PRODUCT CHANGE NOTIFICATION

Date: November 06, 2015
PCN: PCN LEDIL 112 a, b, c, d

Subject: PCN 112.b – Change of product mechanical design

Affected products: C14305_STELLA-CLAMP-CXA15-18
Included in assemblies: FCN14412_STELLA-A
FCN14661_STELLA-A

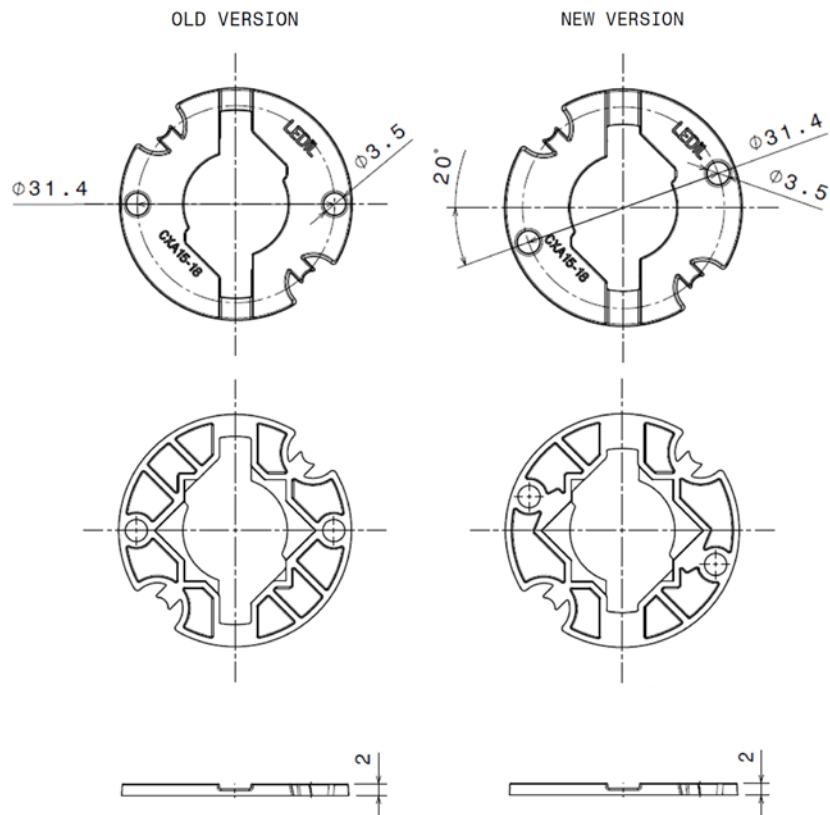
Description: As part of our continuous improvement process regarding the quality of our products LEDiL has moved the screw holes in C14305_STELLA-CLAMP-CXA15-18 to improve mechanical functioning between different COB versions.

Changes: Screw hole positions have been changed accordingly.
